STAFF ANALYSIS

Case No.:	SLUP-21-1244249	Agenda #: N-12
Location/ Address:	Northwest corner of Rockbridge Road and Mountain Park Trail at 5942 Rockbridge Road in Stone Mountain, Georgia.	Commission District: 4 Super District: 7
Parcel ID:	18 035 01 001	
Request:	For a Special Land Use Permit (SLUP) in the R-100 (Single-Family Residential) District to construct a Place of Worship and an accessory skills development center, international visitor guest house, gymnasium, educational garden, groundskeeper quarters, and religious education facilities.	
Property Owner:	Chinagozi Sarah Ugwu	
Applicant/Agent:	Casswell Design Group	
Acreage:	3.001 acres	
Existing Land Use:	Two vacant residential structures	
Surrounding Properties:	Single-family homes to the north, east, south, and west.	
Adjacent Zoning:	North: R-100 South: R-100 East: R-100 West: RSM and R-100	
Comprehensive Plan:	SUB (Suburban) Consistent <input checked="" type="checkbox"/>	Inconsistent <input type="checkbox"/>

Staff Recommendation: FULL CYCLE DEFERRAL

SHEET TITLE
SLUP CONCEPTUAL SITE PLAN
 PROJECT
 STONE MOUNTAIN SKILLS & WORSHIP CENTER
 THE NONPROFIT ORGANIZATION FOR SKILLS EMPOWERMENT
 EDUCATION AND LEADERSHIP INSTITUTE, INC.
 5942 Rockbridge Rd Stone Mountain, GA 30087

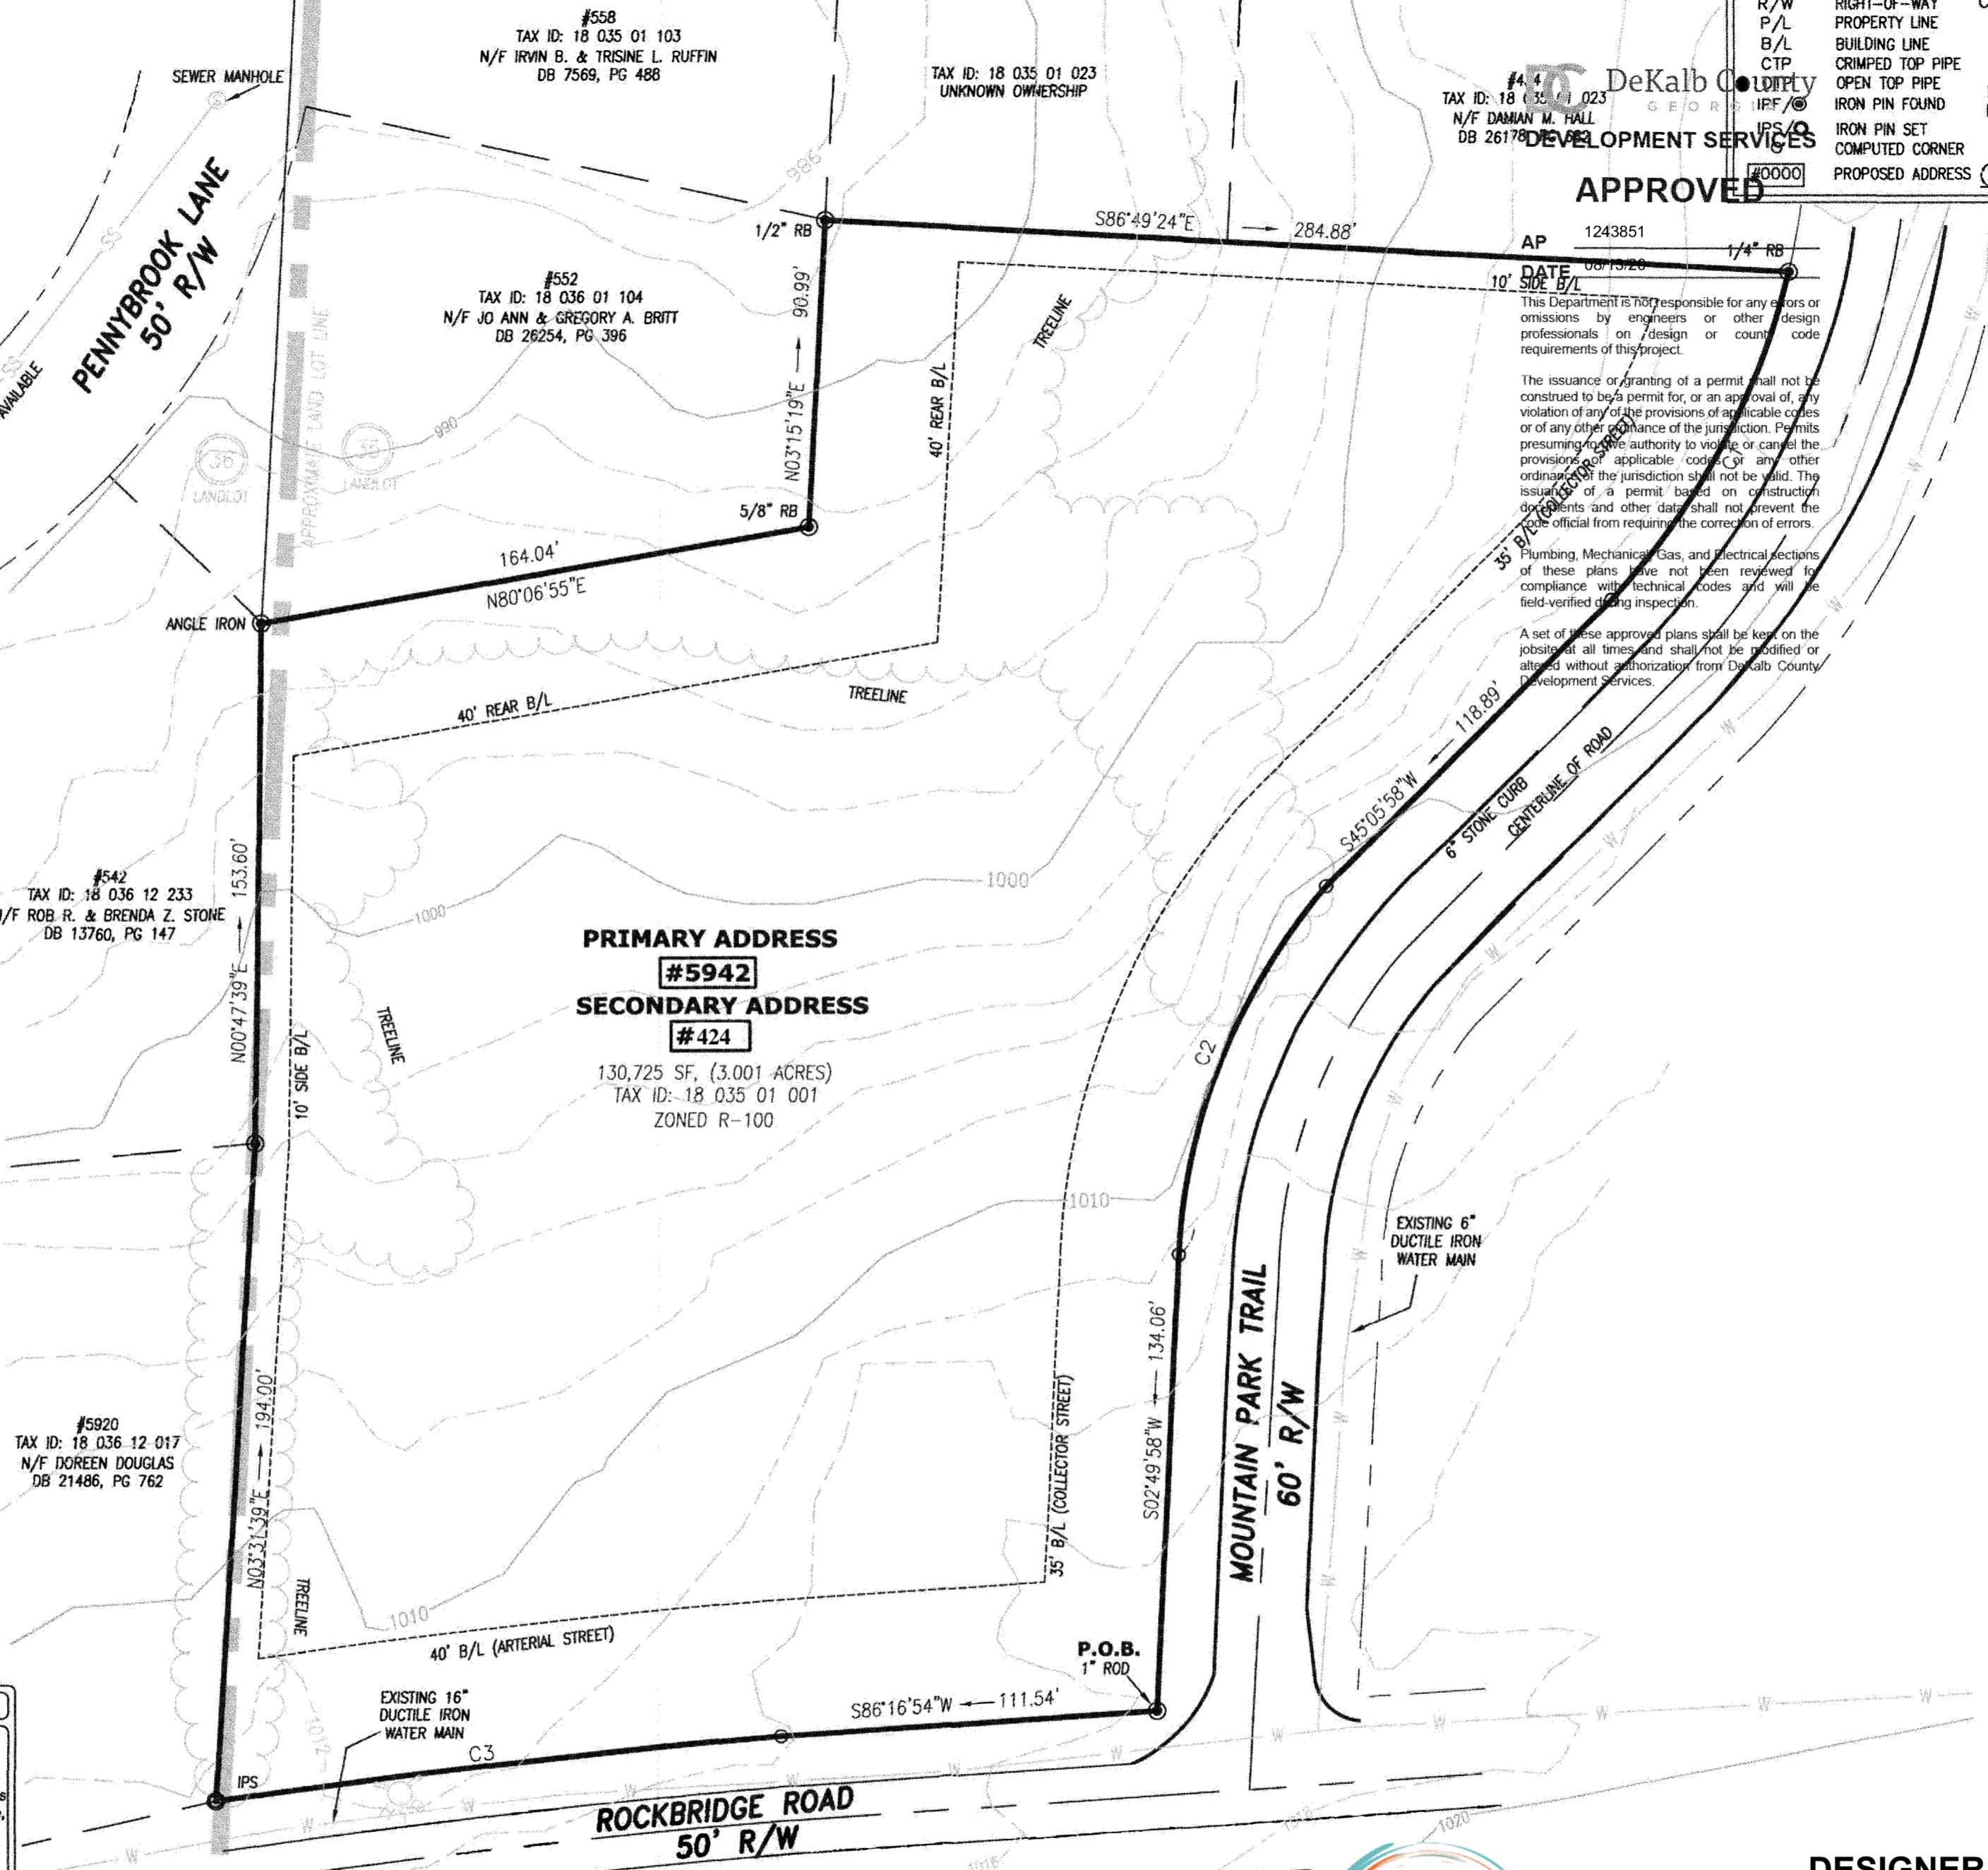
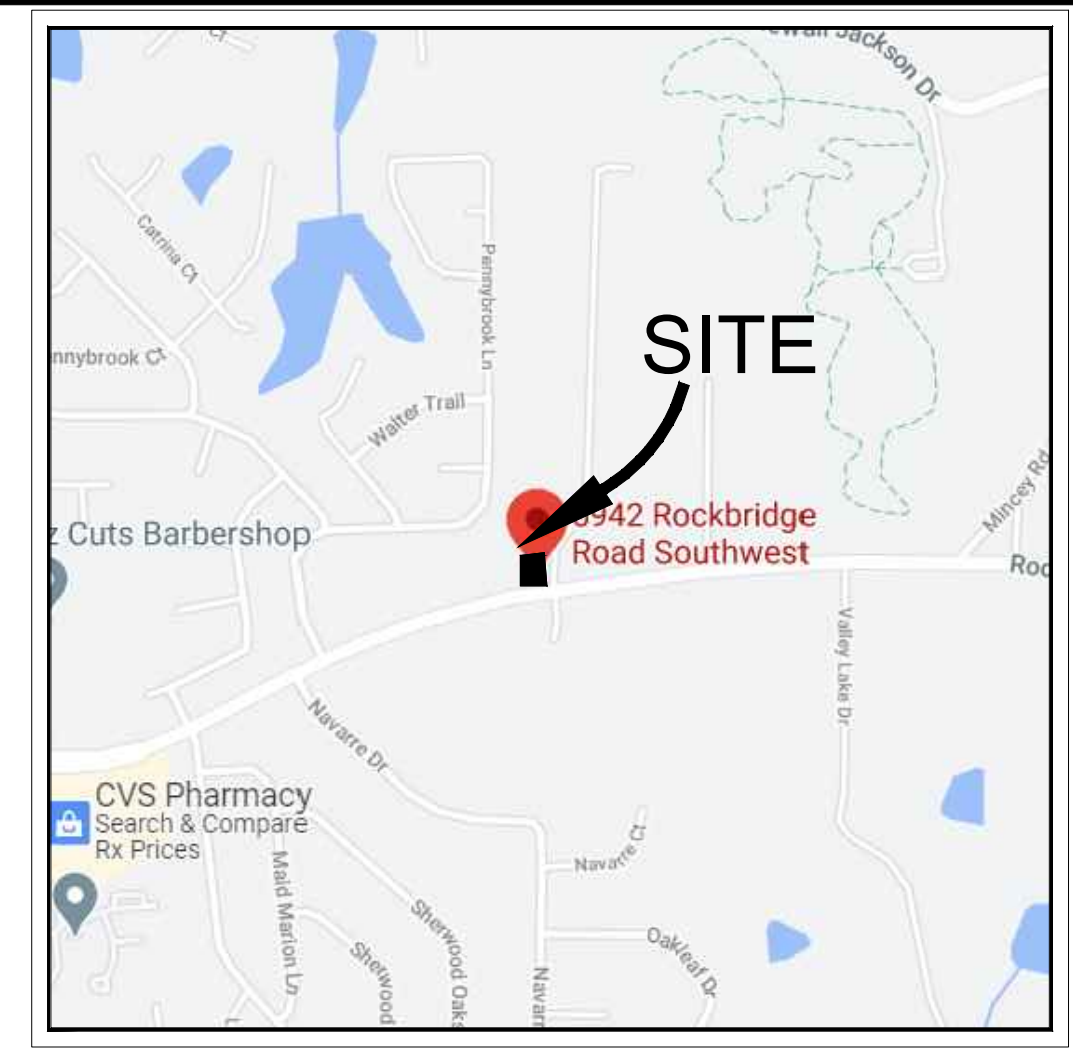
Based on the submitted site plan and information it cannot be determined at this time if the proposed SLUP request is compatible with surrounding properties (Section 7.4.6.B). Planning Department recommends that this application be “deferred, full cycle” to allow the applicant’s traffic impact study to incorporate the full scope of proposed accessory uses and have the study’s recommendations reviewed by the DeKalb County Transportation Department (including if/when the secondary access off of Mountain Park Trail is necessary to ensure safe and convenient traffic flow), as well as consider if parking areas can be reduced to allow for more open space and less potential water runoff impacts on surrounding properties.

Based on the submitted site plan, all proposed buildings are at least 50 feet away from adjacent residential properties along the north and west property line. The existing house to be used as a groundskeeper residence is only 10 feet away from the property line, but that home appears to be a pre-existing non-conforming structure. Additionally, that home is consistent with the building materials and building height of the homes in the Mountain Park Trail Subdivision, will not be expanded, and will only be used as a residence to ensure compatibility with the adjoining residential neighborhood.

1,500 square feet, and the site plan is providing 99 parking spaces which exceeds the maximum number of parking spaces allowed. Planning Department is recommending a full cycle deferral to allow the applicant to consider reducing the parking to comply with the maximum allowed, which would result in more open space and less potential water run-off impacts to surrounding properties. It appears that the existing residential structure on the north side of the property that will be used as a groundskeeper residence may exceed the maximum accessory building size of the zoning ordinance and may require a variance from the Board of Zoning Appeals. However that existing building will only be used as a residence and will not be expanded.

N12. Requesting a traffic study be completed prior to zoning to determine the impacts of the development on the intersection of Rockbridge Road at Mountain Park Trail and the proposed driveway on Rockbridge Road. Only one access point of Mountain Park Trail. The access point on Mountain Park Trail must be shifted to the rear property line away from Rockbridge Road. Please note the minimum driveway/street separation required in Section 14-200 (6). Remove acceleration lane from Rockbridge Road frontage. Provide direct pedestrian access from public right of way to the proposed destinations. Rockbridge Road is classified as a minor arterial. Please note the infrastructure requirements in Chapter 5 of the Zoning Code and Chapter 14-190 of the Land Development Code. A right of way dedication of 40 from centerline or such that all public infrastructure (sidewalks/streetlights) are within right of way, whichever greater. Required: 10- foot landscape strip, 6-foot sidewalk, bike lanes, streetlights. Mountain Park Trail is classified as a local. Please note the infrastructure requirements in Chapter 5 of the Zoning Code and Chapter 14-190 of the Land Development Code. A right of way dedication of 27.5 feet from centerline or such that all public infrastructure (sidewalks/streetlights) are within right of way, whichever greater. Required: 6- foot landscape strip, 5-foot sidewalk, streetlights. All access points must meet minimum intersection and stopping sight distance requirements per AASHTO Greenbook for 35 mph and presented (signed and sealed by a professional engineer)with the land development permit documents.
